PARTS & SERVICE NEWS

REF NO.	AT96174
DATE	Nov. 13, 1996

SUBJECT: REPAIR MALFUNCTION OF MAIN MONITOR PANEL

PURPOSE: To introduce repair procedures of the malfunctions of the main monitor panel on WA200-3 thru WA470-3 wheel loaders.

(1) Supplementation of a harness

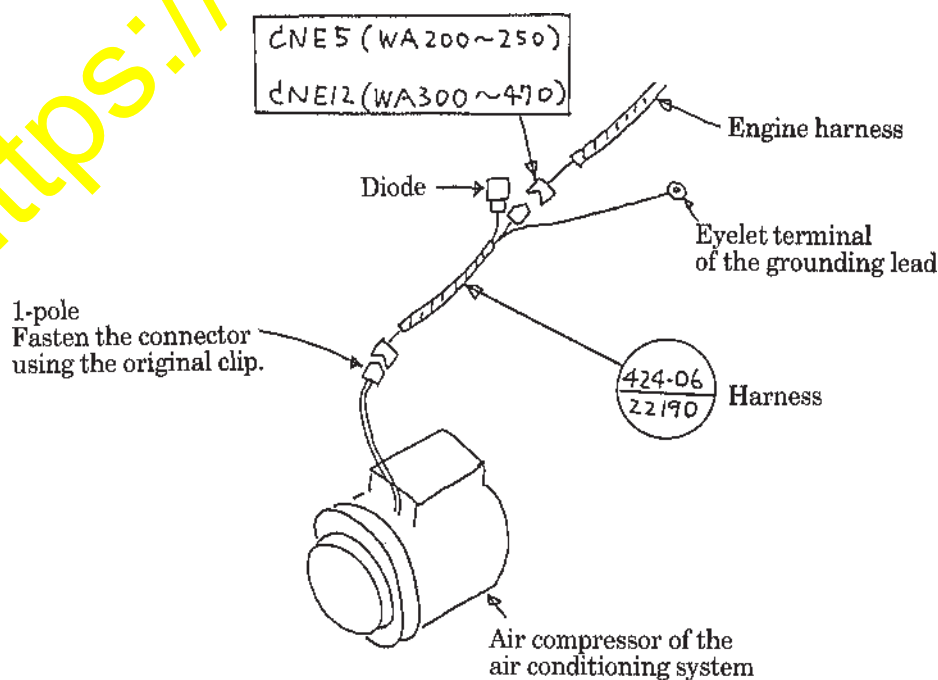
To suppress noise occurring from the electromagnetic clutch of the air compressor for the air conditioning system, a diode has been supplemented to the electromagnetic clutch harness.

Disconnect the air compressor connector (CNE5 with the WA200 thru WA250 and CNE12 with the WA300 thru WA470) and connect the prepared harness (424-06-22190) in supplementation.

① WA200-3 (102E Engine)

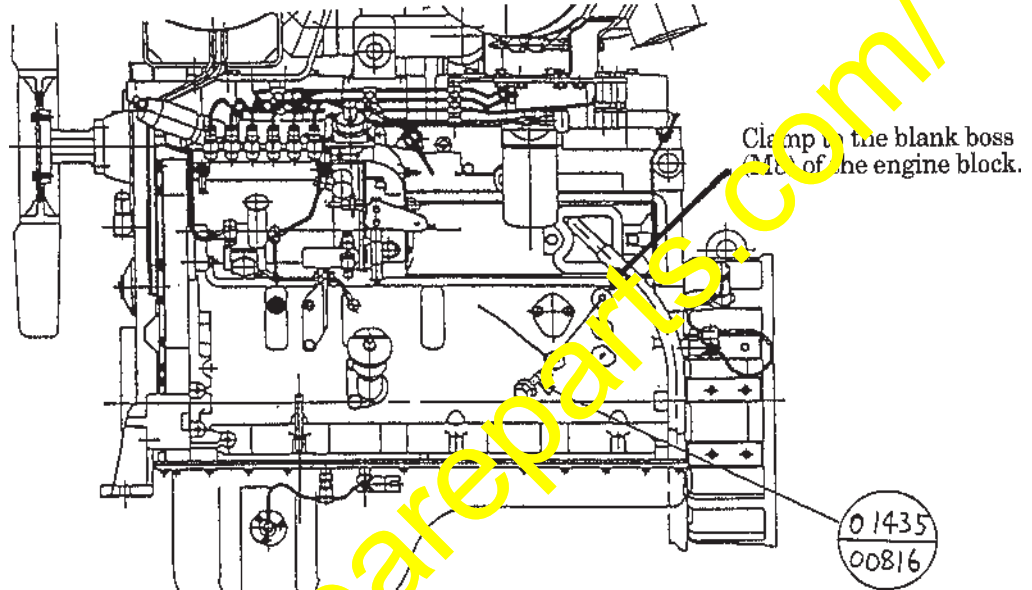
★ Be careful about the clamping position which is different with each vehicle model. Meanwhile, the bolt tightening torque should be according to the ordinary torque specifications of the KES.

Clamp the eyelet terminal of the supplemented harness (424-06-22190) to the engine block or the rear frame.
